**SEAS DEADLINE 6 RESPONSE to APPLICANTS's SUBMISSIONS**  
**SINCE DEADLINE 5, ISH3, Action Points and ExQ3**  
**LANDSCAPE & VISUAL and CULTURAL HERITAGE**

**PINS Ref:** EN020026  
**DEADLINE 6:** APRIL 13, 2026

# EN020026 SEA LINK DCO – DL6: RESPONSE BY NICHOLAS BRIDGES

## ZTV ANALYSIS – IP ref FA62B0DA

**Figure 14. Sea Link EN020026-000343-6.4.2.1 ES Figures Suffolk Landscape and Visual Part 7 of 7, page 7**  
 CUMULATIVE SCHEMES (MAJOR PROJECTS) SCREENED ZONE OF THEORETICAL VISIBILITY - EAST ANGLIA ONE NORTH AND EAST ANGLIA TWO OFFSHORE WIND FARMS

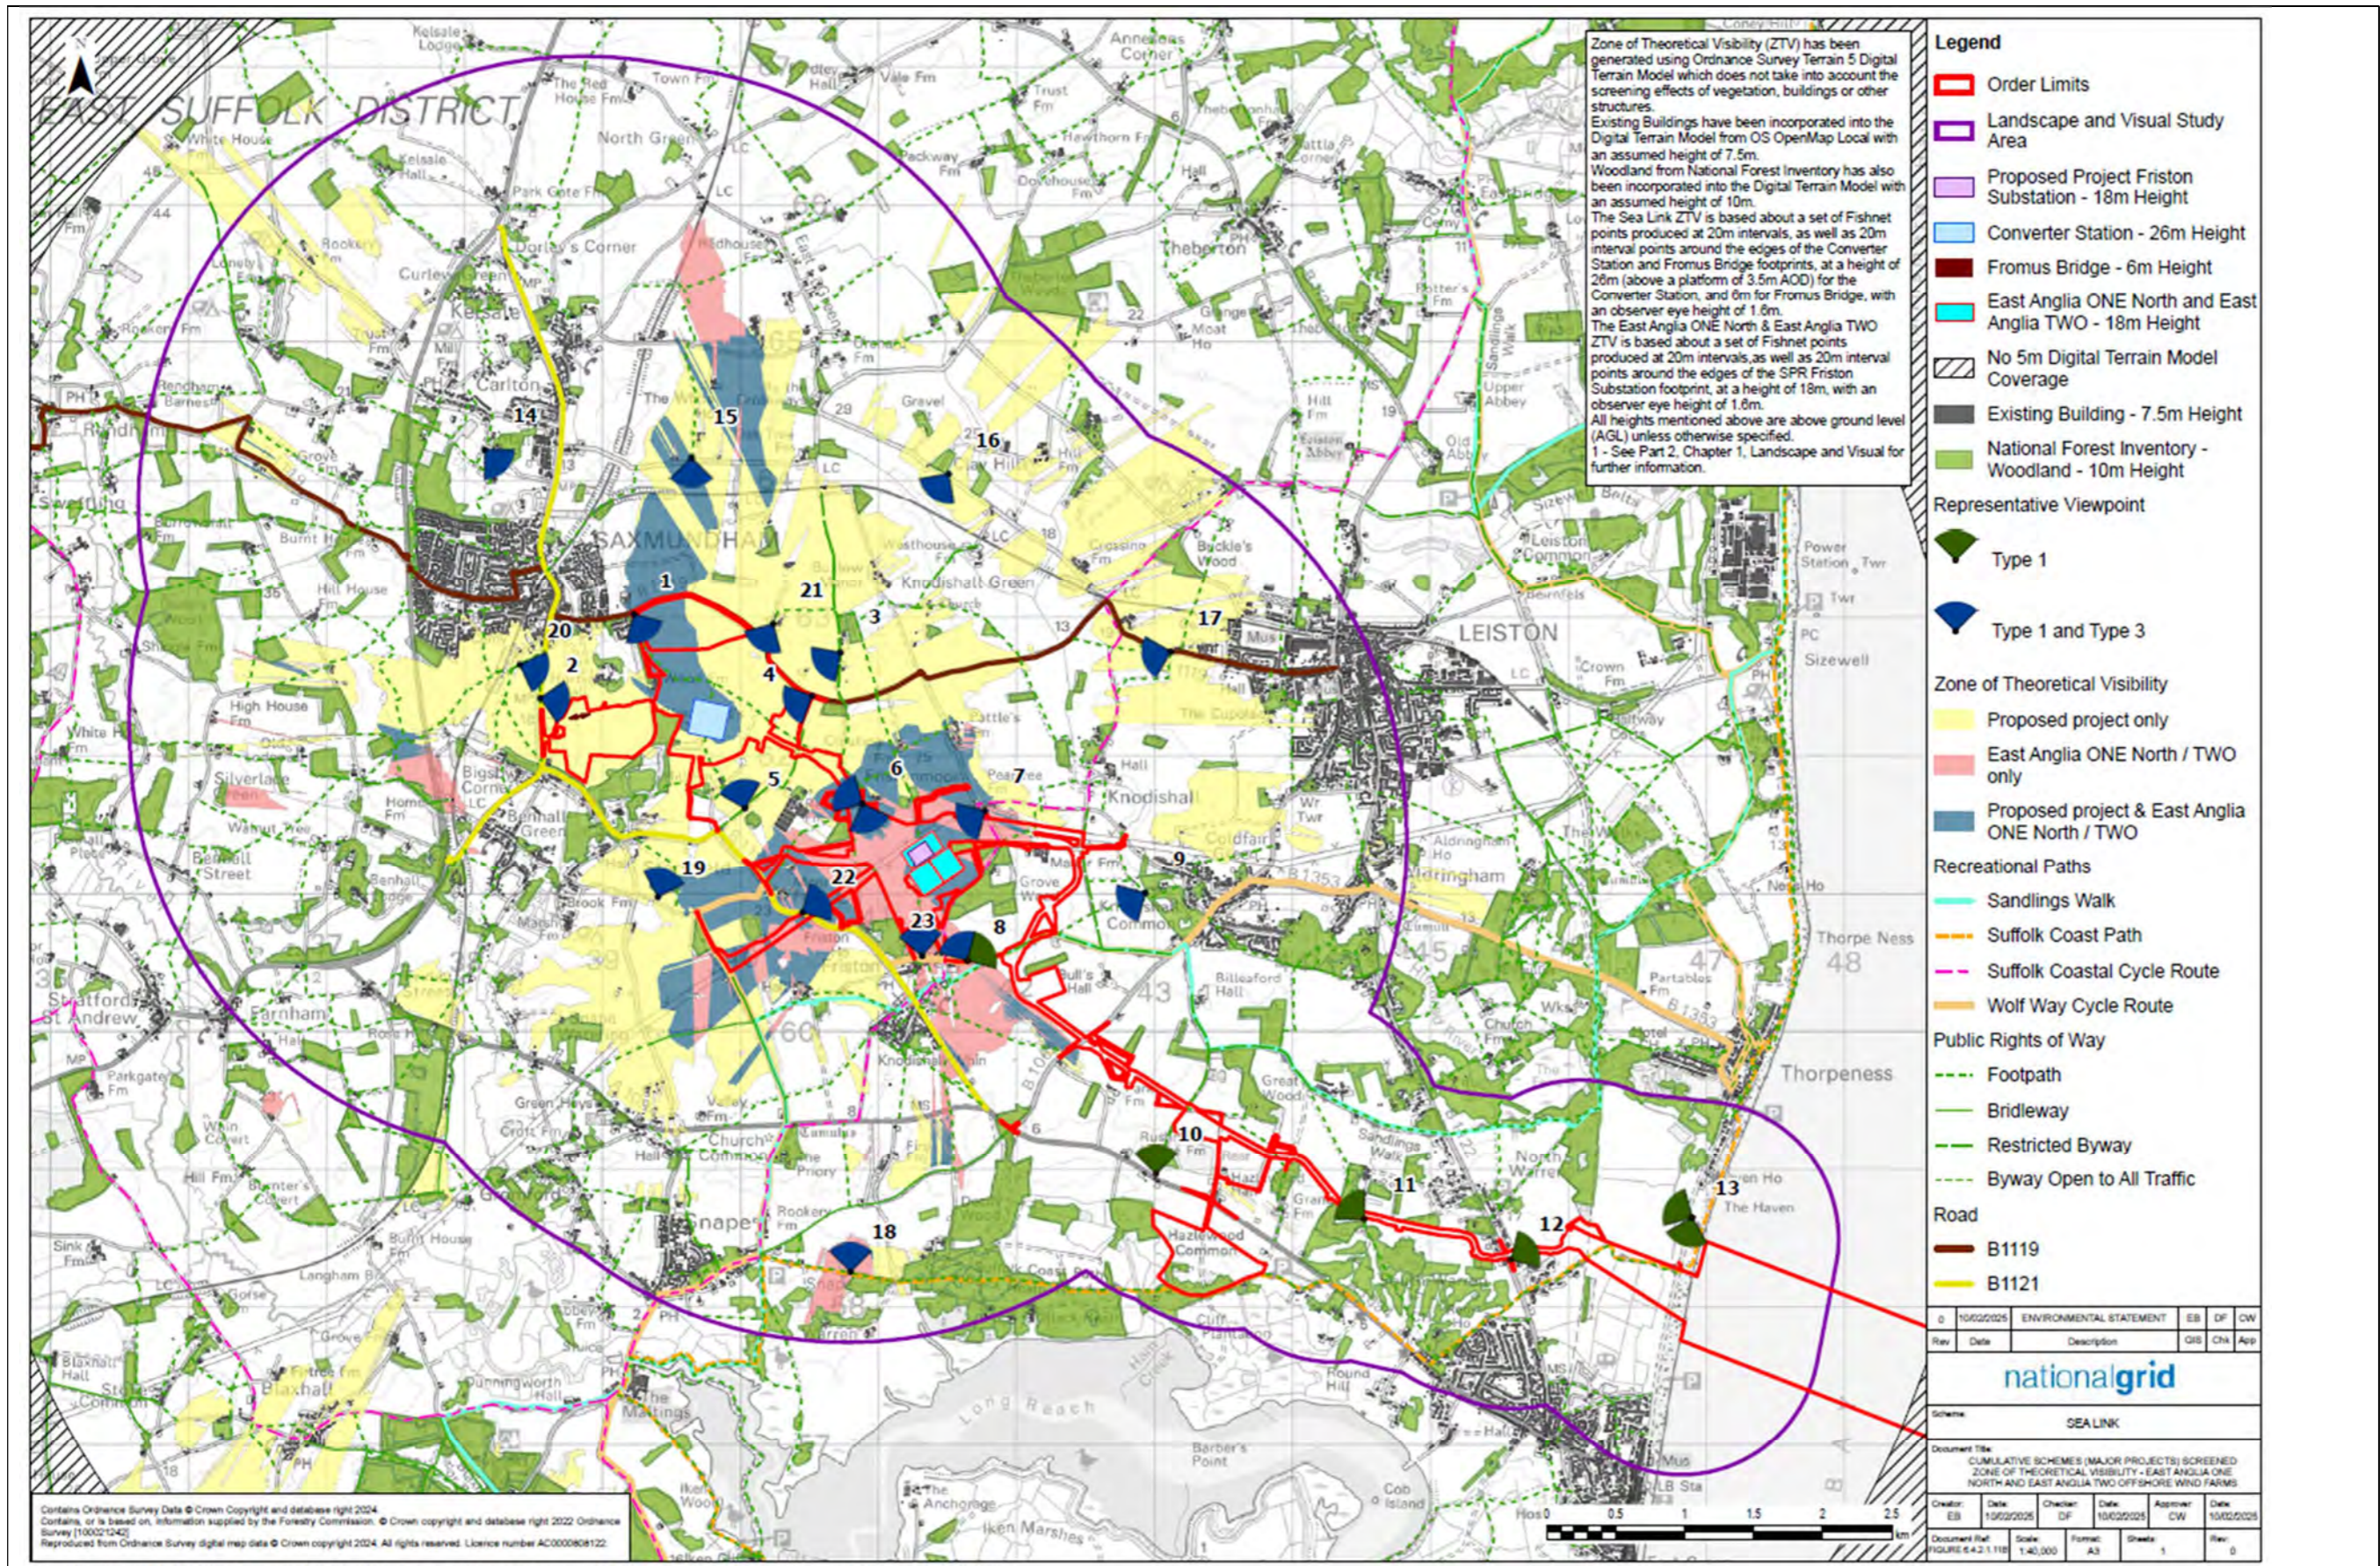
2.10. The 'shadow' patterns illustrate the 'shading' effects of woodland and buildings. The ZTV plans of the same proposed volumetric parameters (**Figures 12 to 17** below) show far less visibility than its PEIR ZTV plans. The accompanying textual details of the model's constraints are exactly the same (see the schedule below).

2.11. The **first question** is: why are the PEIR and DCO plans so completely different? Were the heights in the model changed? Were the shadowing criteria altered? Which is correct? If the DCO is correct, were the EA1N and EA2 ZTVs incorrect? These are simple technical points which can be explained easily.
